RECALL 22V729 / 2022-556 REMEDY INSTRUCTIONS

Make(s): SALEM, WILDWOOD & OZARK
Model(s): MANY, SEE BELOW
Model Year(s): MANY, SEE BELOW

A secondary means of strapping to the fresh water tank to the chassis may not have been installed.

FIGURE 1

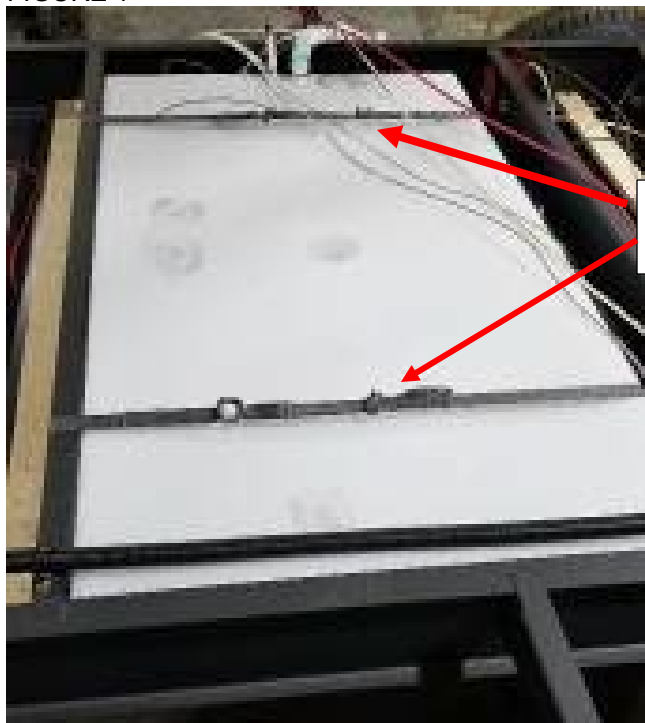
- REMOVE UNDERBELLY PANEL AND SET ASIDE WITH FASTENERS;
- IF THE HOLDING TANK HAS STRAPS AROUND THE TANK AND CROSS-MEMBERS (FIG. 1) TAKE PHOTOS;
- INSPECT THE FLOATING CROSS-MEMBER AND ENSURE IT HAS TWO FASTENERS ON EACH SIDE (TOTAL OF 4) (FIG. 2);
- REASSEMBLE ANY REMOVED UNDERBELLY;
- SUBMIT PHOTOS WITH CLAIM INSPECTION CODE ONLY.

FACTORY INSTALLED 1 1/4" NYLON WEB STRAPPING

FIGURE 2

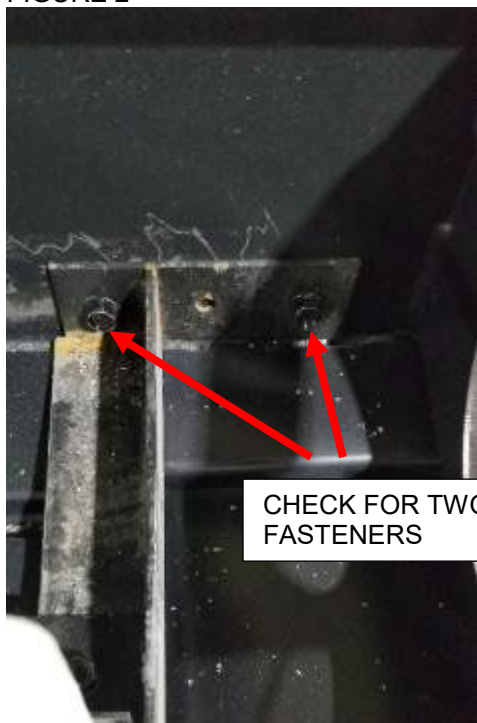
STEP 3: INSPECT AND ENSURE THE FLOATING CROSS-MEMBER HAS A MINIMUM OF TWO (2) 3/8" SELF-TAPPING FASTENERS (FIG. 2), ADD IF MISSING;

CHECK FOR TWO FASTENERS
